Re: PG&E Response to Final Independent Evaluator Report Concerning 2020 Wildfire Mitigation Plan Compliance (Docket No. 2021-IE)

Pacific Gas and Electric Company (“PG&E”) respectfully submits this response to the *Final Independent Evaluator Annual Report on Compliance* for PG&E’s 2020 Wildfire Mitigation Plan (“IE Report”) from Bureau Veritas North America, Inc. (“BVNA”).

**Figure 1: Scope of EVM Work**

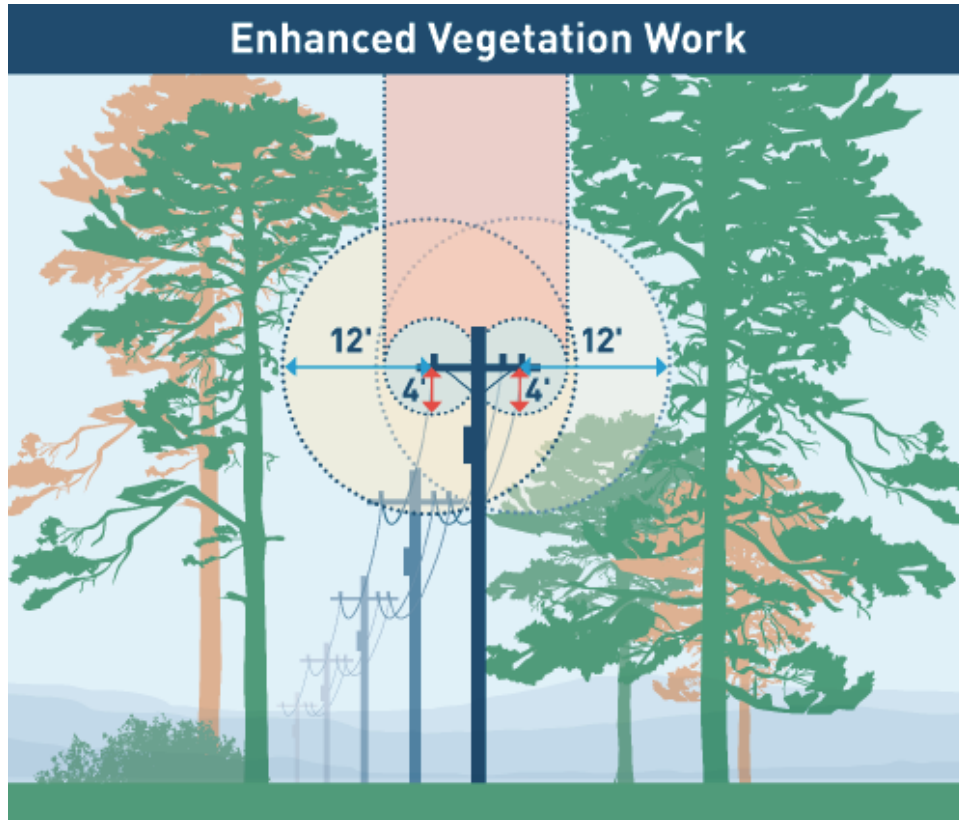
Upon receipt of the IE Report, we sent our Vegetation Management Work Verification teams to review BVNA’s findings and to take necessary corrective action. Our Work Verification teams inspected each of the 105 sites identified by BVNA as being out of compliance with our EVM Pre-Inspection Procedure, TD-7106P-01EVM. Our inspectors confirmed that six locations were out of compliance, and are in the process of determining whether an additional nine locations are out of compliance or not.<sup>16</sup> Thus, our inspectors confirmed that the number of locations out of compliance totals only between 6 and 15, or 0.43% to 1% of the audited population. Our EVM procedure states that the pre-inspector must prescribe clearance of any vegetation if the vegetation is currently within the four-foot radius plane of primary conductor, or if the vegetation will enter the four foot radius plane before the next routine/compliance cycle. A visual depiction of the clearance requirements for the EVM program can be found in Figure 1 below.

Nine locations were identified by BVNA as potentially having compliance issues because there existed tree branches that encroached within the extended overhang zone (the vertical plane above the conductors depicted in Figure 1). However, our Verification Team is working on determining whether these trees were in compliance at the time they were worked based on clearance requirements and whether they should be marked as non-compliant. We have

For the six locations where our Work Verification team definitively determined that the location was not in compliance with our EVM standards, we expedited work orders and performed work to bring these areas into compliance. Of the remaining 99 locations, 52 locations had trees within the 12-foot plane of the conductor but were in compliance with the EVM standard. These trees were not found to be within four-foot radius of the primary conductor, or to have the potential to encroach within the four-foot radius of the primary conductor, as prescribed in Procedure TD-7106P-01.<sup>17</sup>

identified these trees for work and they are on schedule to be trimmed through routine maintenance.
